HP 9133/9134 D/H/L Service Manual

Manual part number: 5957-6560

Edition 2
E0488

Service Note History

Required Screws in Exchange Flexible

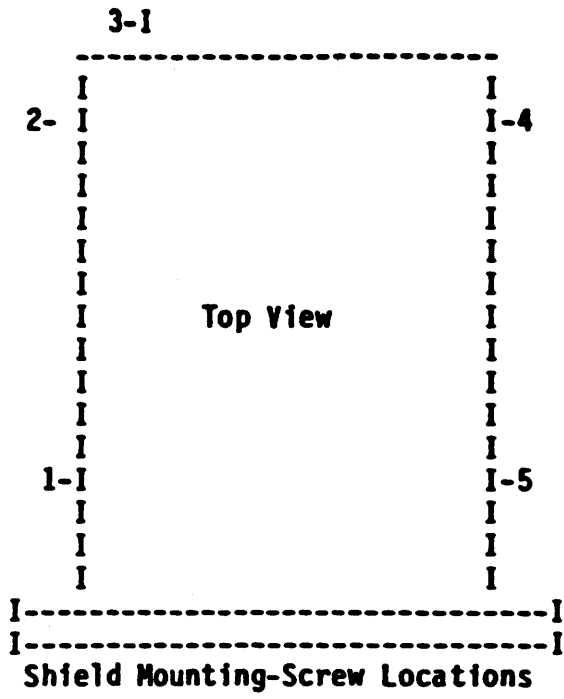
The 09114-69511 Flexible Disc drive is currently used in three products; the 9114A, the 9122D/S, and the 9133D. There are 5 possible locations for mounting-screws that attach the shield to the frame of the drive. Each product requires a different minimum number of screws. In some cases, screws must NOT be installed in certain locations.

All drives in the 9133D's have been shipped with the proper mounting-screws. However, many of the EXCHANGE drives shipped prior to September 1984 contained only the one rear mounting-screw. The exchange drive is now being shipped with the MAXIMUM number of screws to accommodate all products that use the drive.

The 9133D requires screws in locations 2 and 3 ONLY. Screws 1,4, and 5 MUST BE REMOVED.

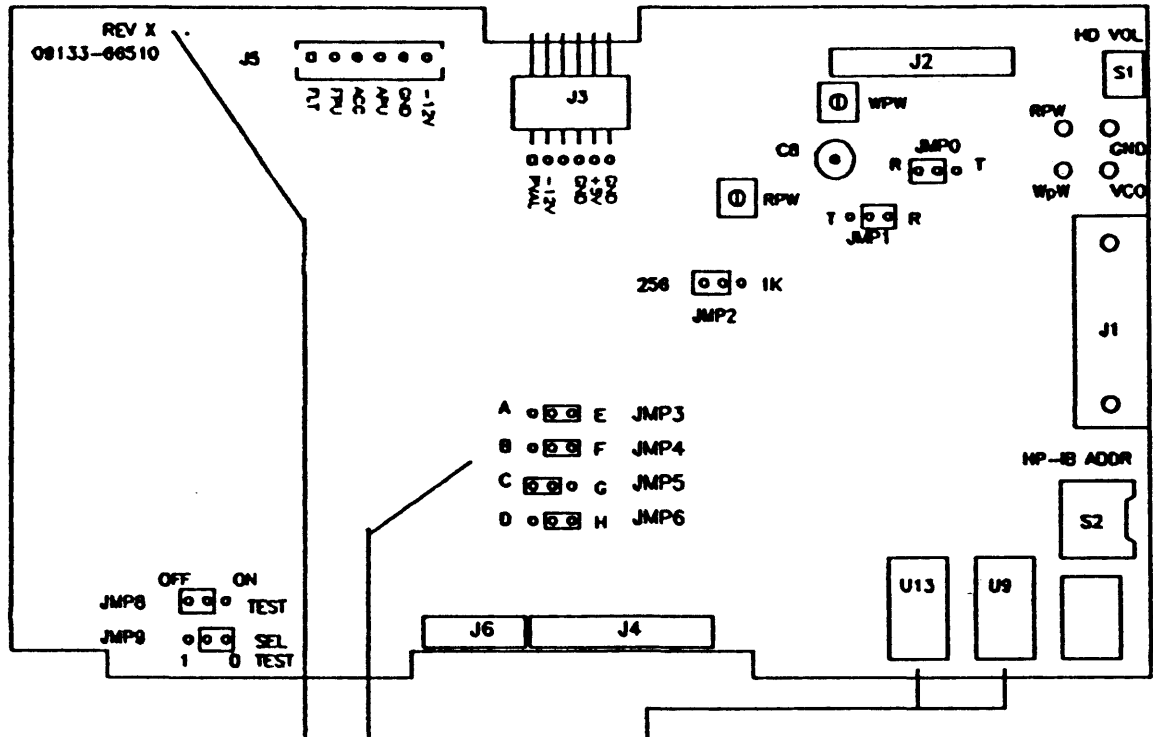
A revised controller PCA is being shipped in all 9133D Disc Drives. The new controller will be in 9133D products beginning at approximately serial number 2419A14750. This controller will also be shipped in all 9133D products with serial number prefix of 2511A and above.

The controller assembly has been revised to use a single IC to perform the hard disc controller and ECC functions which were previously performed by two IC's. Additional changes include a change to a different IC for the phase lock loop for the hard disc, and silkscreen changes to correct an error on the original PCA.

Both the Rev B and the Rev C controller assemblies will be used as exchange assembly 09133-69520. All service inventory of the original exchange assembly 09133-69510 must have firmware updated per service note 9133D-4 before being used to service any 9133D Disc Drives with serial number prefix 2511A or above. Firmware should not be updated in 9133D Disc Drives which are repaired.

Jumpers JMP3-JMP6 must be installed as shown in the figure on the next page to assure correct operation. Note that the jumper configurations shown here differ from those shown in the service documentation for the 9133D.

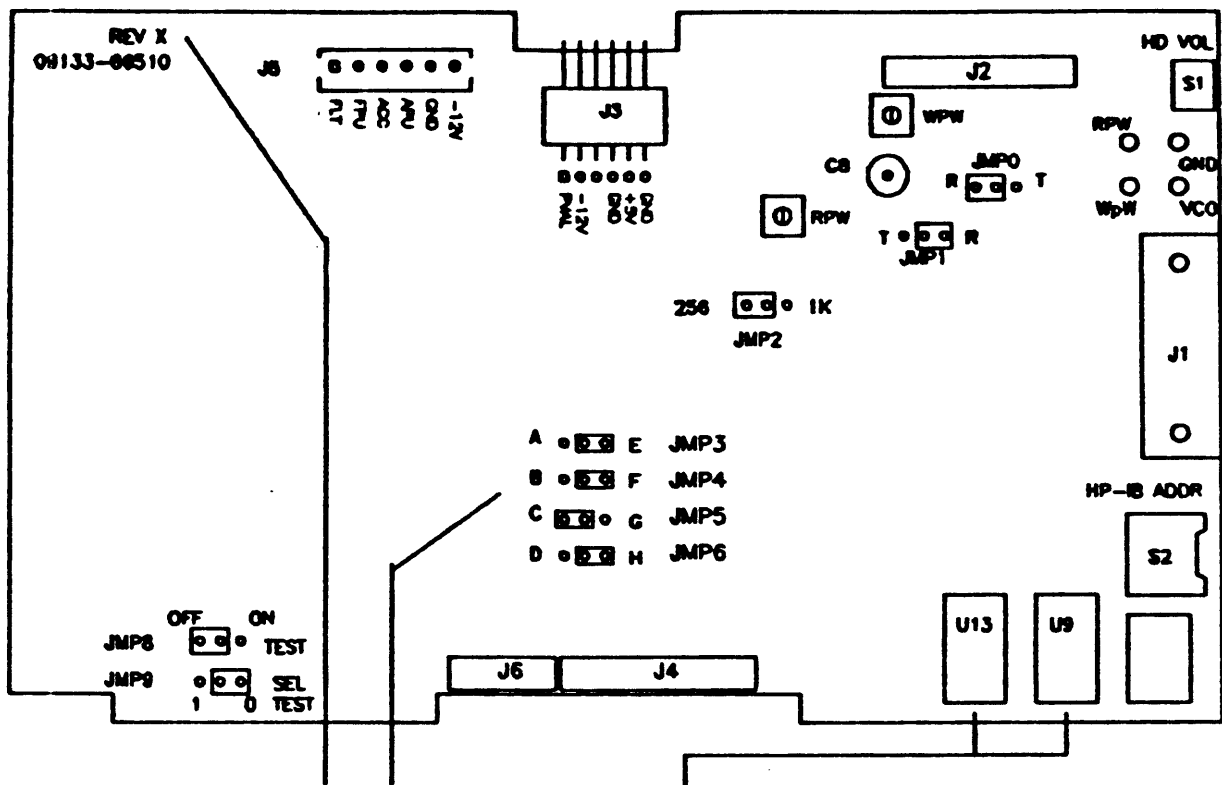
The 09133-69520 Controller PCA which is used in the 9133D, 9133H, 9134D, and 9134H may be a board which has '09133-66510 Rev B' or '09133-66510 Rev C' etched on the board. Jumpers JMP3-JMP6 must be configured properly for the product in which it is installed. Please note that the correct jumper configuration is determined by the product in which it is installed and the revision letter on the PC assembly.

Set JMP3-JMP6 as shown in the figure on the next page to assure that the jumpering is correct for the product in which the controller PCA is installed. Also note that JMP2 will have to be changed when a controller PCA is installed if the disc drive is option 001.

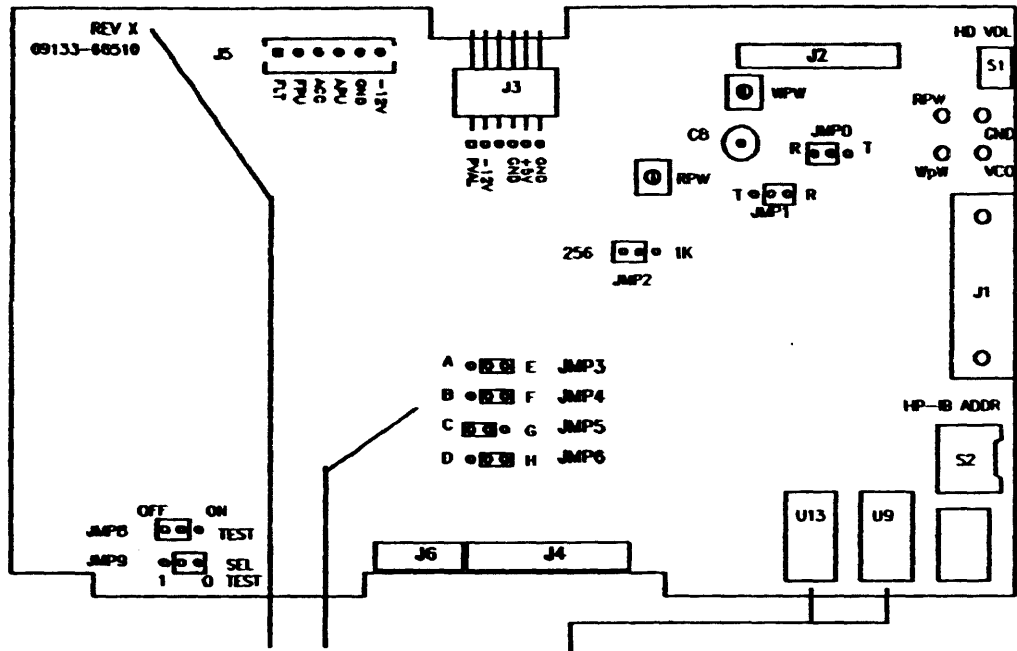
The 09133-69530 Controller PCA which is used in the 9133D, 9133H, 9133L, 9134D, 9134H, and 9134L may be a board which has '09133-66510 Rev B' or '09133-66510 Rev C' etched on the board. The correct configuration of JMP3-JMP6 on the 09133-69530 is determined by the product in which it is installed *and the revision letter on the PC assembly.*

Set JMP3-JMP6 as shown in the figure on the next page to assure that the jumpering is correct for the product in which the controller PCA is installed.

Note that if the revision letter on a controller PCA which is being replaced is not the same as the revision letter on the controller PCA which is being installed, the jumpering on the two PCA's will not be the same.
